Job Number: 22NL037-A3

Date: 21st July, 2023

Access Review Report for 18-28 Simpson St, Dundas Valley, NSW

Prepared for: Part 5 Application

Figure 1: General arrangement – External works

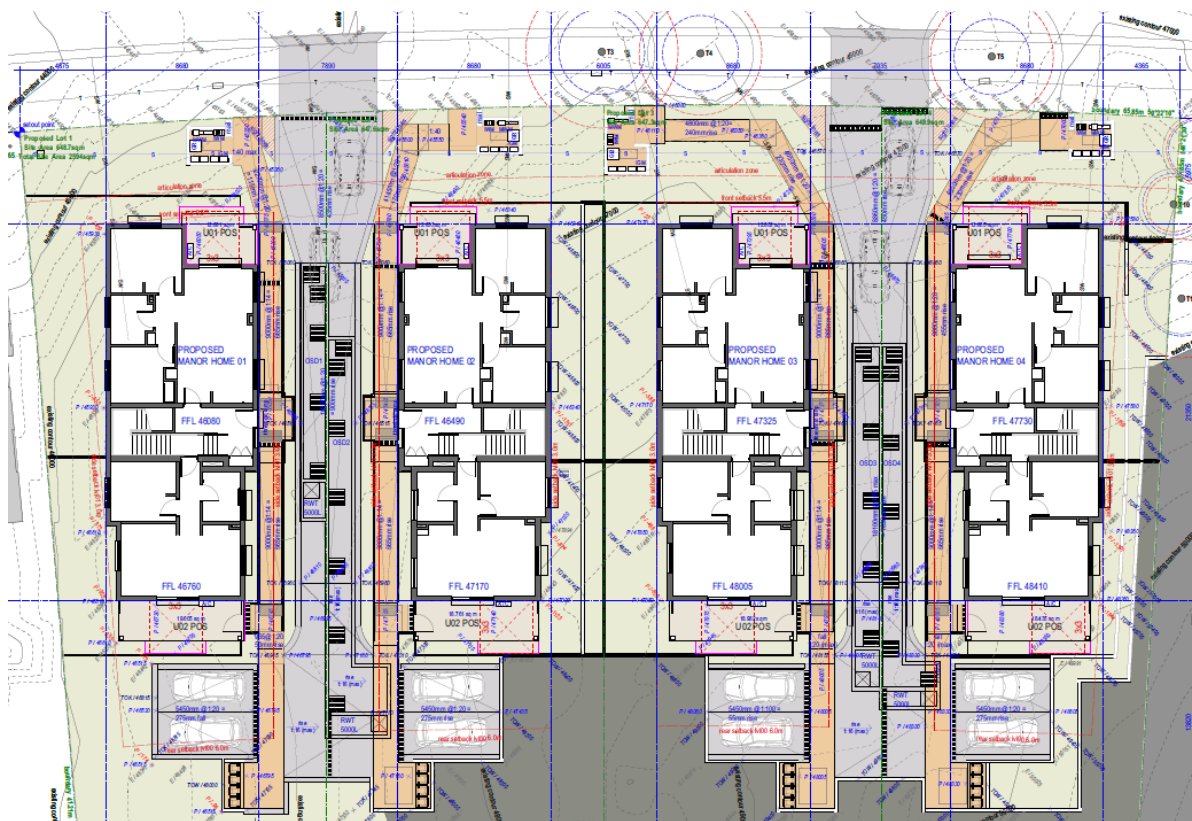
BCA Clause			Compliance	Comments/ Recommendation
Part D4 Access for People with Disability				
D4D2(4)	General building access requirements	Class 2	Complies More details to be verified at CC stage	Access is provided from the 4 separate pedestrian entries to entry doors of all the manor houses by means of accessible pathway.
		Common areas - From a pedestrian entrance <i>required</i> to be <i>accessible</i> to at least 1 floor containing <i>sole-occupancy units</i> and to the entrance doorway of each <i>sole-occupancy unit</i> located on that level. - To and within not less than 1 of each type of room or space for use in common by the residents, including a cooking facility, sauna, gymnasium, <i>swimming pool</i>, common laundry, games room, individual shop, eating area, or the like. - Where a ramp complying with AS 1428.1 or a passenger lift is installed— a) to the entrance doorway of each <i>sole-occupancy unit</i>; and b) to and within rooms or spaces for use in common by the residents, located on the levels served by the lift or ramp.

D4D3	Access to buildings	a) An <i>access way</i> must be provided to a building <i>required</i> to be <i>accessible</i>: - from the main points of a pedestrian entry at the allotment boundary; - from another <i>accessible</i> building connected by a pedestrian link; and - from any <i>required accessible</i> car parking space on the allotment.	Complies More details to be verified at CC stage	A 1.25m minimum wide pedestrian path is provided from the boundary to Manor houses for each separate pathway. There is an accessible entry for each unit at ground floor.

b) In a building required to be accessible, an access way must be provided through the principal pedestrian entrance, and: i. through not less than 50% of all pedestrian entrances including the principal pedestrian entrance; and ii. in a building with a total floor area more than 500 m², a pedestrian entrance which is not accessible must not be located more than 50 m from an accessible pedestrian entrance, except for pedestrian entrances serving only areas exempted by D4D5.	Complies More details to be verified at CC stage	All pedestrian entries from footpath to all unit are accessible.

Figure 2: General arrangement – Ground floor

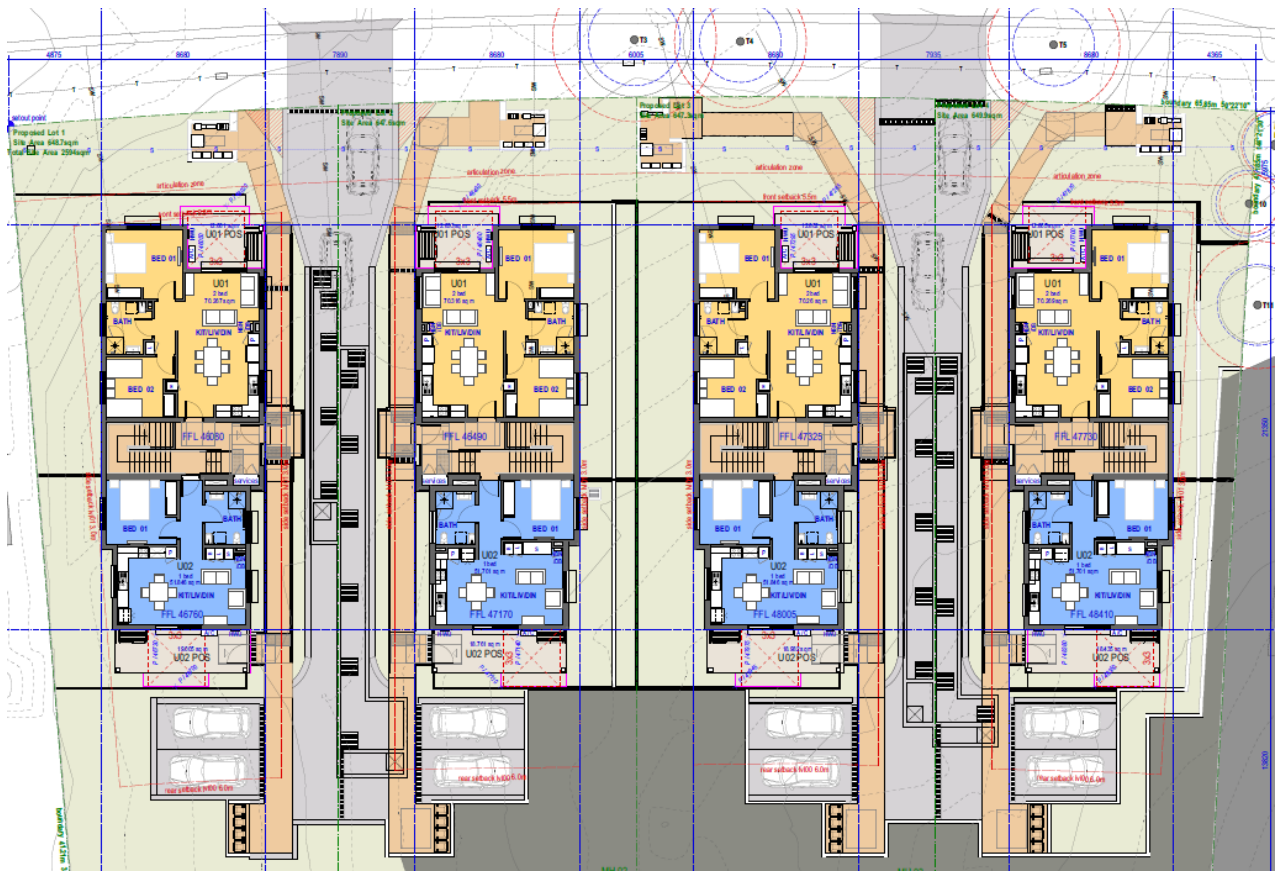
Threshold ramp ➤ Should have maximum rise of 35mm for a maximum length of 280mm ➤ Should have a maximum gradient of 1:8 ➤ Must be located within 20mm of door leaf which it serves	Compliances are achievable Details to be verified at CC stage	Providing a threshold ramp of maximum length of 280mm with maximum difference in levels of 35mm at entry doors for the POSs from the units will lead to compliance. Refer to Section A.6 with figure 7 for more details.
		ii. for a stairway, except a fire-isolated stairway, clause 11 of AS 1428.1; ➤ Setback ➤ TGSi ➤ handrail	Compliances are achievable	Providing below features for stairs on ground floor leading to first floor will lead to compliance: a) Setback b) TGSi

➤ Risers ➤ Nosing ➤ Luminance contrasting strip	Details to be verified at CC stage	c) handrail d) Risers e) Nosing f) Luminance contrasting strip Refer to Section A.5 with figure 6 and Section A.9 figure 10 and 11 for more details.
		iii. for a fire-isolated stairway, clause 11.1(f) and (g) of AS 1428.1; 11.1.f (f) At the nosing, each tread shall have a strip not less than 50 mm and not more than 75 mm deep across the full width of the path of travel. The strip may be set back a maximum of 15 mm from the front of the nosing. The strip shall have a minimum luminance contrast of 30% to the background. Where the luminous contrasting strip is affixed to the surface of the tread, any change in level shall comply with Clause 7.2 and Clause 7.3. 11.1.g (g) Where the luminance contrasting strip is not set back from the front of the nosing then any area of luminance contrast shall not extend down the riser more than 10 mm.	N/A	No fire stairs proposed

c) <i>accessways</i> must have: i. passing spaces complying with AS 1428.1 at maximum 20 m intervals on those parts of an <i>access way</i> where a direct line of sight is not available; and ii. turning spaces complying with AS 1428.1: (A) within 2 m of the end of <i>access ways</i> where it is not possible to continue travelling along the <i>access way</i>; and (B) at maximum 20 m intervals along the <i>access way</i>; d) an intersection of <i>access ways</i> satisfies the spatial requirements for a passing and turning space; e) a passing space may serve as a turning space;	Complies More details to be verified at CC stage	One passing space is provided complying with AS 1428.1 for each accessible pathway. 30° to <60° turning spaces are provided between ramps and walkway comply with AS 1428.1 for each accessible pathway. 60° to <90° turning spaces are provided at the start and end of pedestrian pathway comply with AS 1428.1 for each accessible pathway. Refer to Section A.4 with figures 3, 4&5 for more details.
